Monticello Nuclear Generating Plant
2807 W County Road 75
Monticello, MN 55362

Monticello Nuclear Generating Plant: Update of Information Related to NRC Order EA-12-049 Mitigation Strategies for Beyond-Design-Basis External Events (TAC No. MF0923)

Monticello Nuclear Generating Plant Implementation of Required Action by NRC Order EA-12-049 Mitigation Strategies for Beyond-Design-Basis External Events

Figure OI 3.2.3.B – 1 – Early Venting - Large Primary System Leak

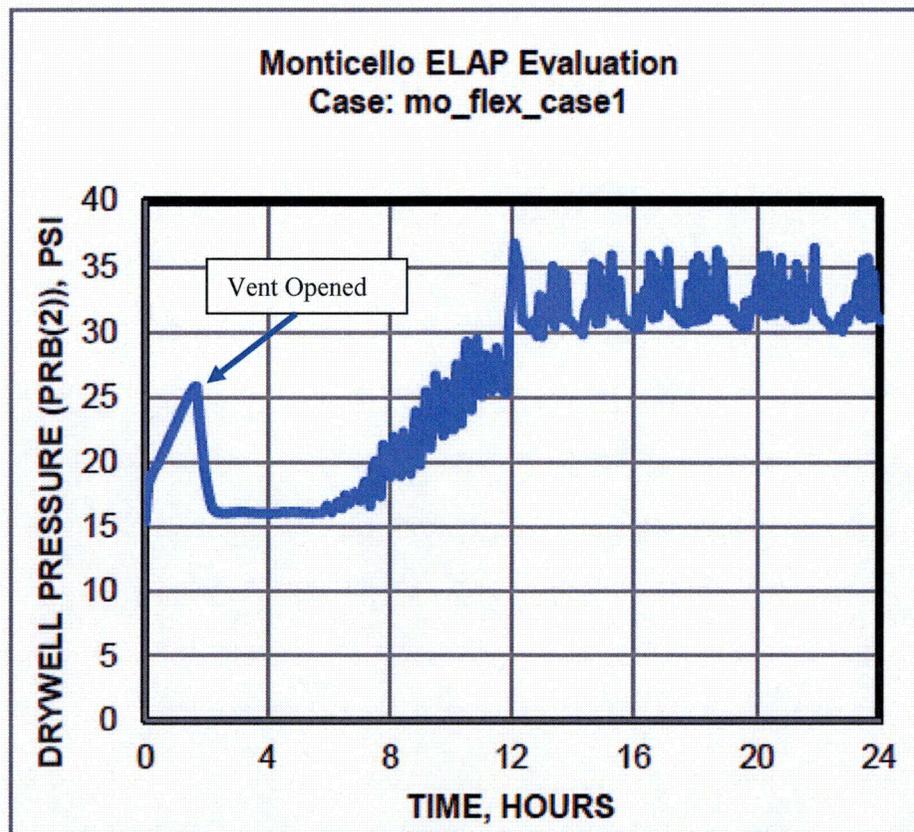
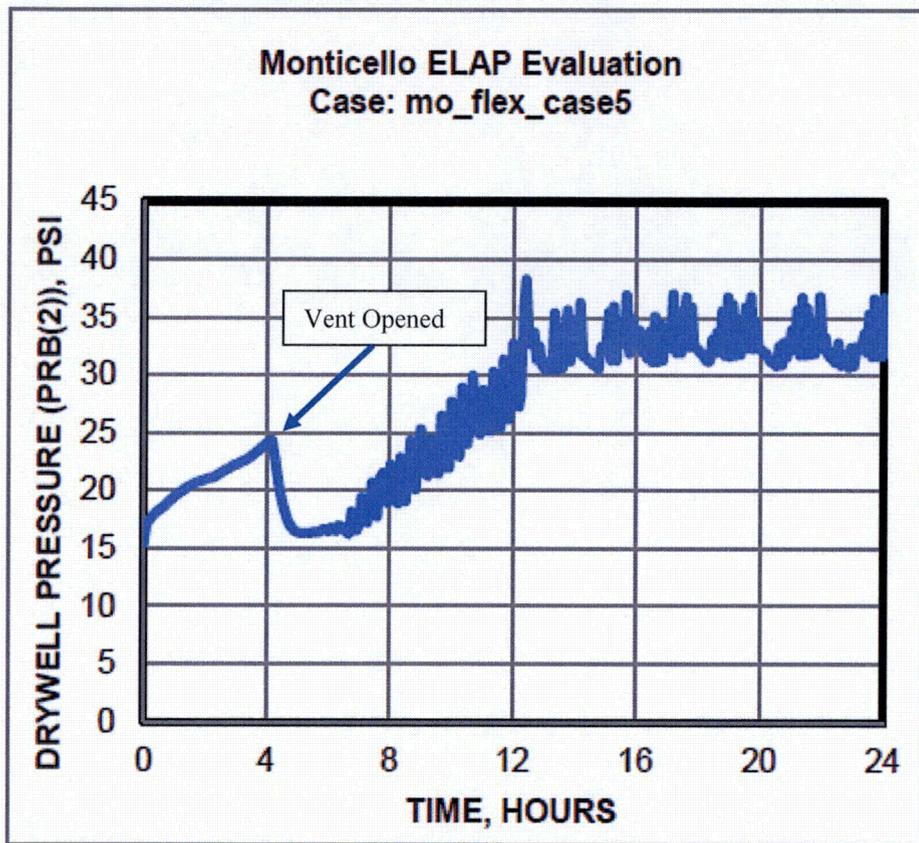
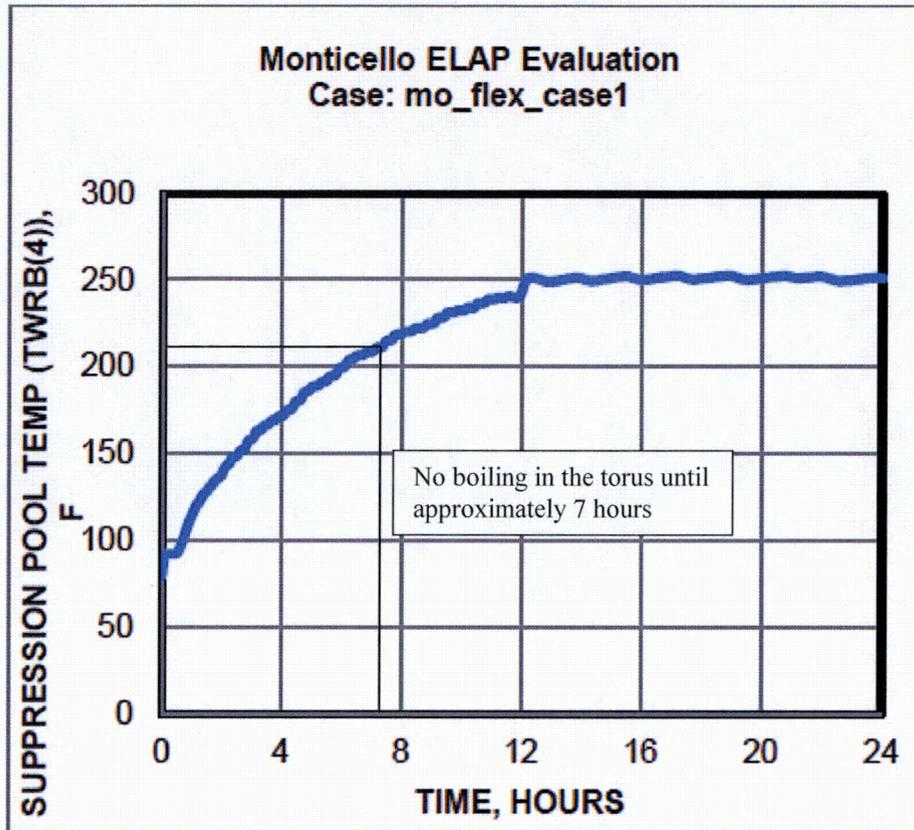
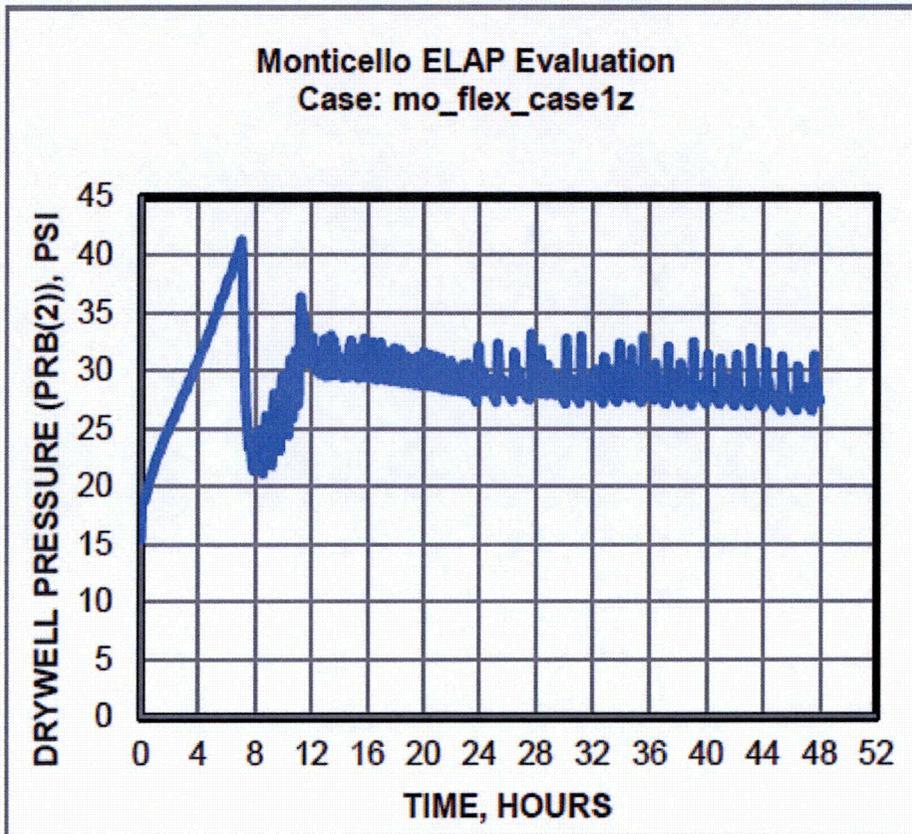
The licensee needs to resolve the issue of the potential for the BWROG revised venting strategy to increase (relative to currently accepted venting strategies) the likelihood of detrimental effects on containment response for events in which the venting strategy is invoked. In particular it has not been shown that the potential for negative pressure transients, hydrogen combustion, or loss of containment overpressure (as needed for pump net positive suction head) is not significantly different when implementing Revision 3 of the Emergency Planning Guidelines/Severe Accident Guidelines (EPG/SAG) vs. Revision 2 of the EPG/SAG.

The following figures show this graphically. Figure OI 3.2.3.B - 1 assumes a large primary coolant leak (165 gpm) and this drives the containment pressure to increase rapidly. This yields an opening of the vent at approximately 1.7 hours.

Figure OI 3.2.3.B - 2 assumes a 30 gpm primary coolant leak and shows a similar but shorter time with containment pressure near atmospheric pressure. Still this shows a vent opening occurring at approximately 4 hours.

In these figures, venting removes the nitrogen overpressure and steam leaking from the primary system; no significant amount of energy is lost from the torus. The nitrogen loss reduces RCIC NPSH so that its flow is limited. There is not much decay heat removed from the containment during this period as shown in Figure OI 3.2.3.B – 3 below. Opening the vent this early is of marginal use and provides some challenges.

What is clear from figures OI 3.2.3.B – 3 and OI 3.2.3.B – 4 is that once the torus is heated up to boiling (Case 1 – around 7 to 8 hours) the containment pressure will be fairly constant (~30 - 38 psia, (15 - 23 psig)) for the next day or more.

However, when the venting strategy criterion is changed to 10 psig and torus temperature greater than 212°F, the containment pressure remains positive with margin. The modified MAAP run is shown below in Figure OI 3.2.3.B - 4. Note, this case was run out to 48 hours instead of 24 hours.

Figure OI 3.2.4.8.B – 1 - Portable FLEX Pump Controls

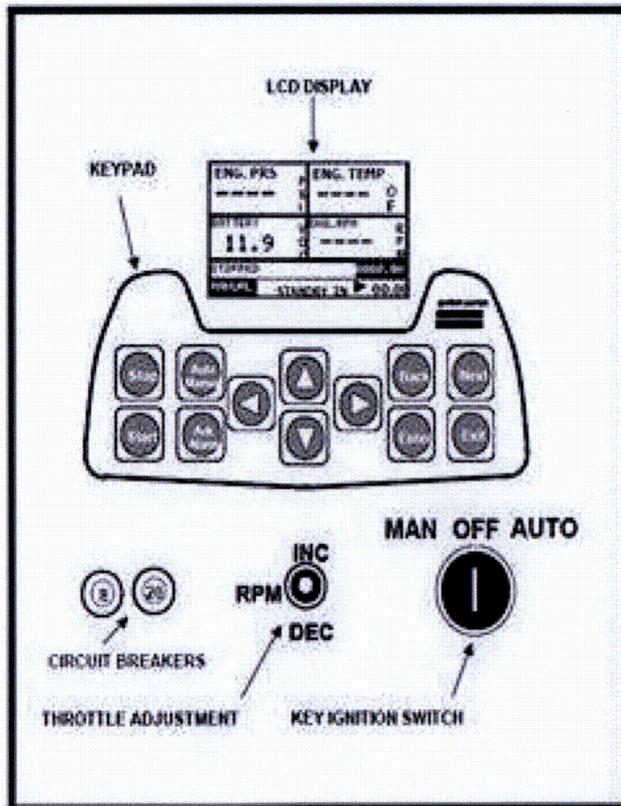
The licensee needs to provide a description of the instrumentation that will be used to monitor portable/FLEX electrical power equipment including their associated measurement tolerances/accuracy to ensure that the electrical equipment remains protected and that operators are provided with accurate information.

The FLEX portable pump engine controls are shown in Figure OI 3.2.4.8.B - 1 below:

- LCD DISPLAY** Backlit LCD display shows operating parameters in default mode (oil press., temp., RPM, voltage).
- KEYPAD** Touch-sensitive pad for maneuvering through menus and editing parameters.
- CIRCUIT BREAKER** 8 and 20 amp circuit breakers.
- THROTTLE ADJUSTMENT** Toggle switch to manually increase and decrease engine RPM.
- KEY IGNITION SWITCH** Select Manual or Automatic panel operation.

Figure 2
GENERAL LOCATION OF TEMPORARY ROAD
(Refer to PART P, Build Temporary Access Road to Site)

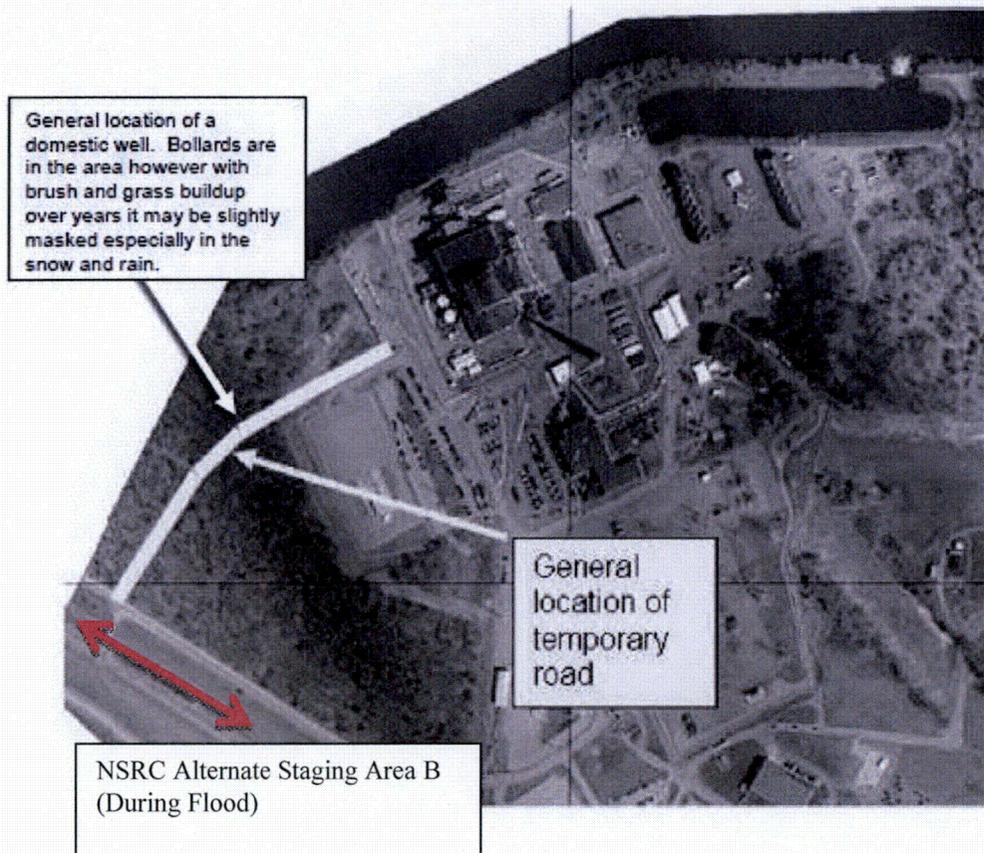
The licensee's integrated plan did not identify Regional Response Center resources, the off-site staging areas, and delivery methods sufficiently in order to evaluate the means to obtain the resources from off site.

If a flooding condition prohibits use of Staging Area B, MNGP procedures include an alternate Staging Area B for offloading of SAFER equipment. MNGP procedures direct a temporary road to be constructed during external flooding events if the main plant road is projected to flood. Figure 2 below shows the general location of the temporary road and the alternate Staging Area B.

The equipment delivered by the NSRC will be delivered off Country Hwy 75 (see red arrow above) and equipment will be moved through the temporary access road and onto the site. The MNGP SAFER Response Plan also includes directions to the alternate Staging Area B.

Figure CI 3.2.1.1.D – 1 – MAAP MNGP Vessel Nodalization Scheme

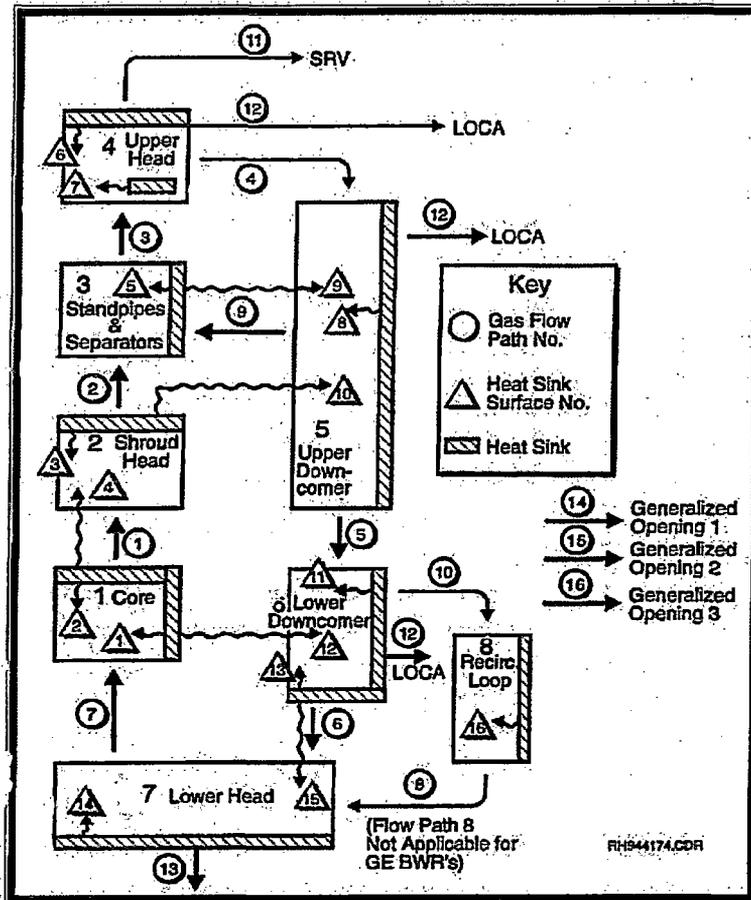
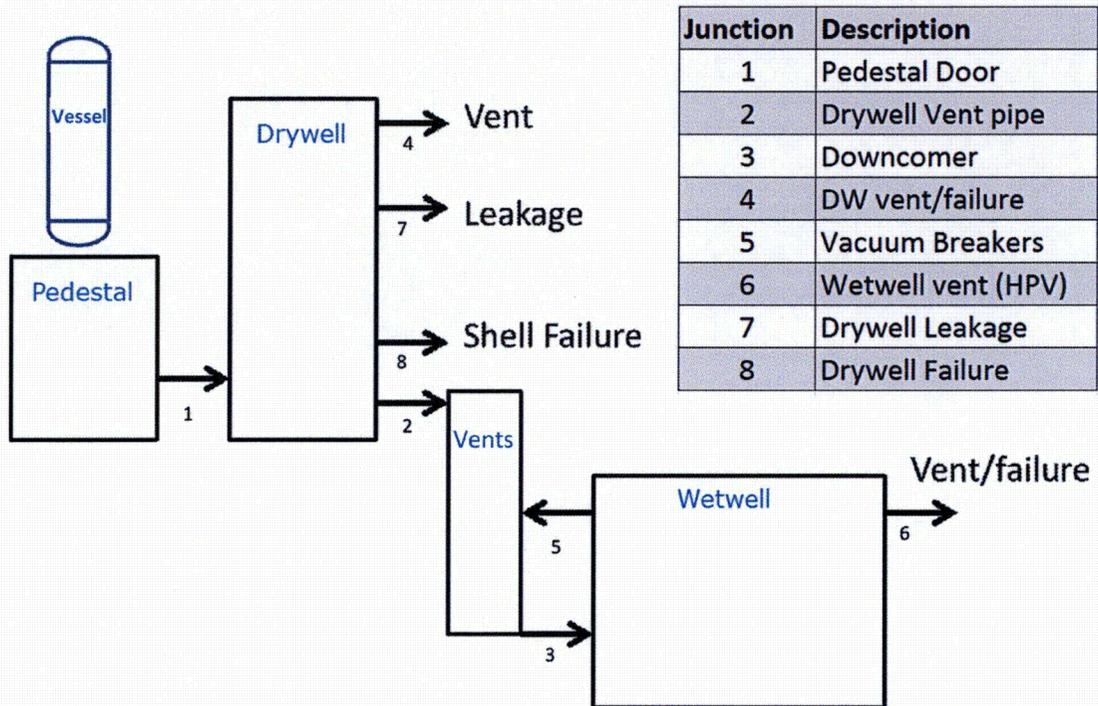
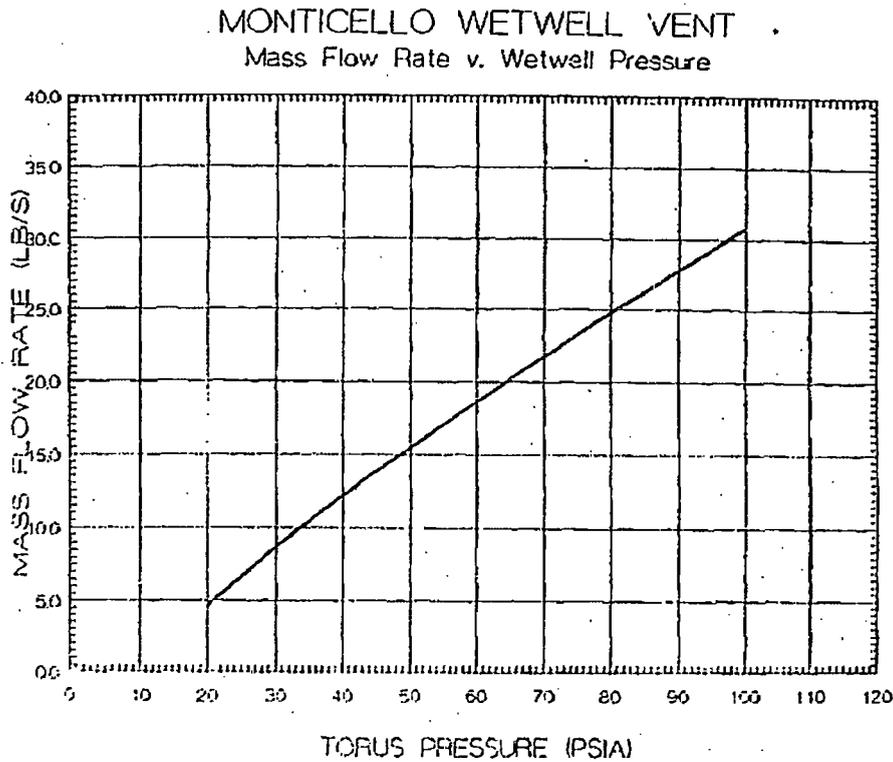
Identify and justify the subset of key modeling parameters taken from Tables 4-1 through 4-6 of the MAAP4 Applications Guidance (EPRI 1020236). This should include response at a plant-specific level regarding specific modeling options and parameter choices for key models that would be expected to substantially affect the ELAP analysis performed for that licensee's plant. Although some suggested key phenomena are identified below, other parameters considered important in the simulation of the ELAP event by the vendor /licensee should also be included.

- a) Nodalization: The reactor vessel nodalization is fixed by the MAAP code and cannot be altered by the user, with the exception of the detailed core nodalization. The MNGP MAAP 4.0.6 parameter file divides the core region into 5 equal volume radial regions and 27 axial regions. The axial nodalization represents 24 equal-sized fueled nodes, 1 unfueled node at the top, and 2 unfueled nodes at the bottom. Figure CI 3.2.1.1.D - 1 below, taken from the MAAP User's Manual, illustrates the vessel nodalization scheme.

Containment nodalization is defined by the user. The standard nodalization scheme is used in the MNGP MAAP 4.0.6 parameter file and represents the following individual compartments:

Figure CI 3.2.1.1.D – 2 below illustrates the MNGP containment nodalization along with an identification of containment flow junctions.

- d) Vent line pressure losses: Vent line pressure loss can be represented in two different approaches. One approach is to input the actual piping flow area along with a discharge coefficient (FCDJ). An alternative approach would be to calculate the effective flow given the estimated piping losses, and input a loss coefficient of 1.0. The MNGP MAAP analysis utilizes the discharge coefficient approach. The MNGP MAAP analysis flow rate out of the hard pipe vent was compared to the MNGP HPV flow curve which is displayed in Figure CI 3.2.1.1.D - 3 below. Figure CI 3.2.1.1.D – 3 was used to develop a function that correlates the torus pressure to the vent flow rate using the discharge
